## HISTORIC AND DESIGN REVIEW COMMISSION

Agenda Item No: 20

**HDRC CASE NO:** 2017-031  
**ADDRESS:** 422 HAYS ST  
**LEGAL DESCRIPTION:** NCB 537 (HAYS ST BRIDGE LANDING IDZ), BLOCK 22 LOT 27  
**ZONING:** IDZ, H  
**CITY COUNCIL DIST.:** 2  
**DISTRICT:** Dignowity Hill Historic District  
**APPLICANT:** William Moore  
**OWNER:** William Moore  
**TYPE OF WORK:** Fencing  
**REQUEST:**

The applicant is requesting a Certificate of Appropriateness for approval to install side yard 4' cedar fence and 4' black metal front yard fence.

# *Materials*

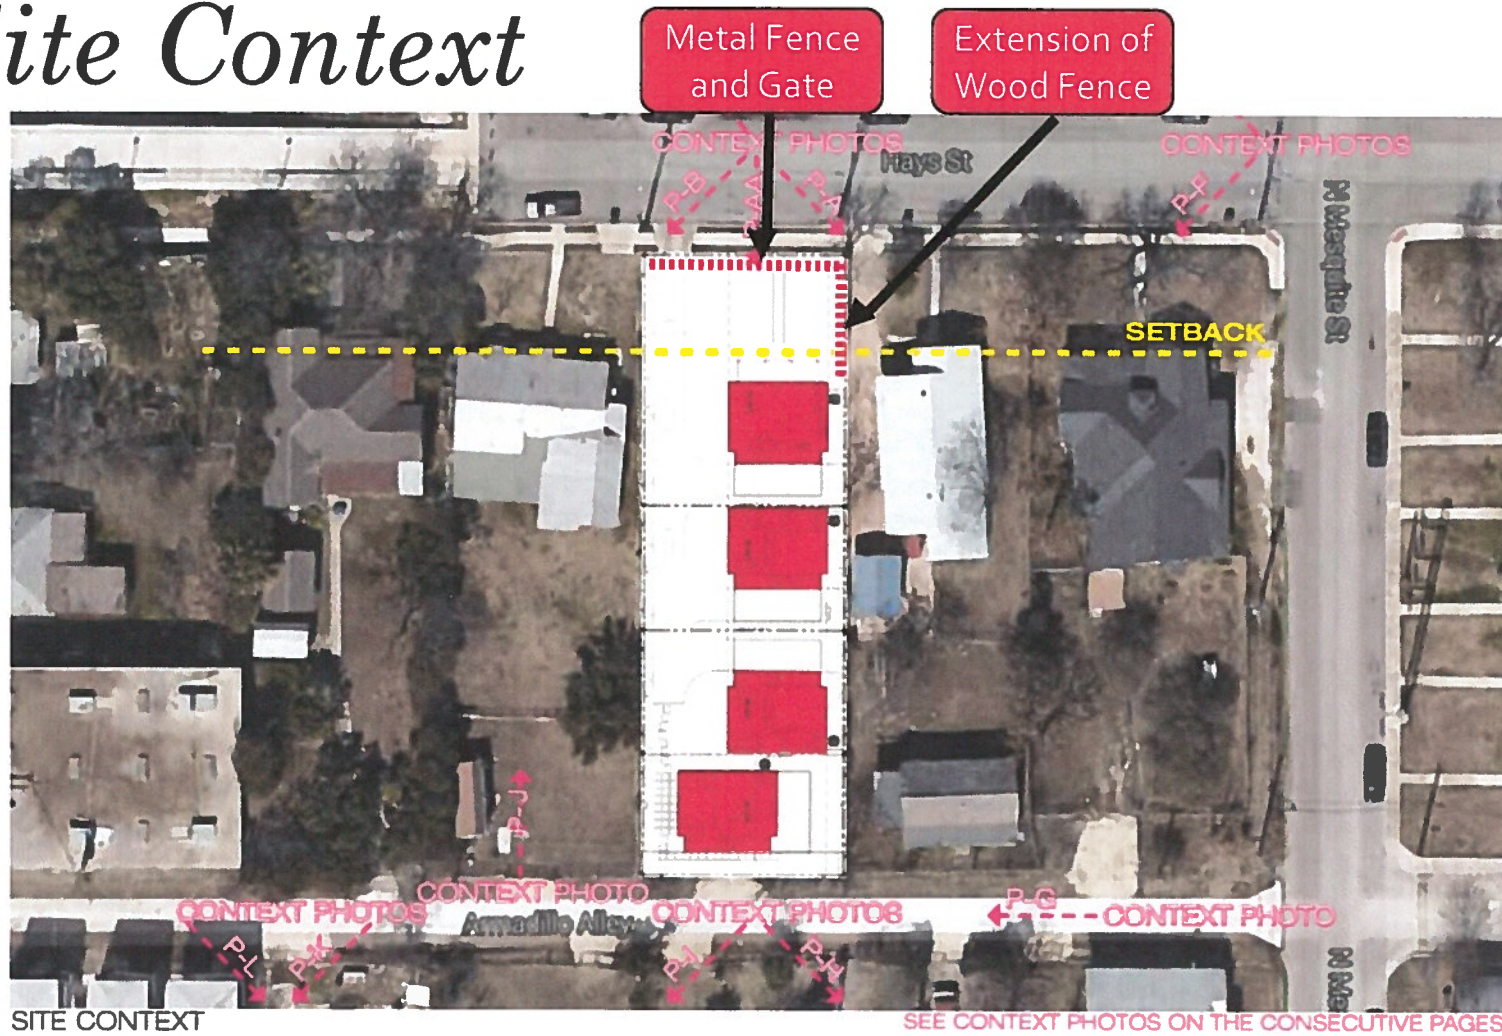
- a. The structure is a two-story new construction home a couple of parcels away from the Hays Street Bridge. It is located in the Dignowity Hill Historic District, designated in 1983.
- b. There is not an existing front yard fence. The proposed front yard fence is a 4' cedar fence along the left property line in front of the front façade and a 4' metal grid fence along the front property fence. According to the Guidelines for Site Elements, new fences should appear similar to those used historically throughout the district in terms of scale, transparency and character and should be located only where fences historically existed. Staff

made a site visit on January 20, 2017, and found while there are various properties along Hays and throughout Dignowity Hill that feature front yard fences, primarily chain link fences, front yard fences are not part of the historic development pattern of the neighborhood. Also the horizontal pattern of the wood fence and the grid pattern of the metal fence are not designs characteristic of fences found when the district was developed. Staff finds that the location of the proposed fences is not consistent with the Guidelines.

Staff does not recommend approval of based on findings a through b.
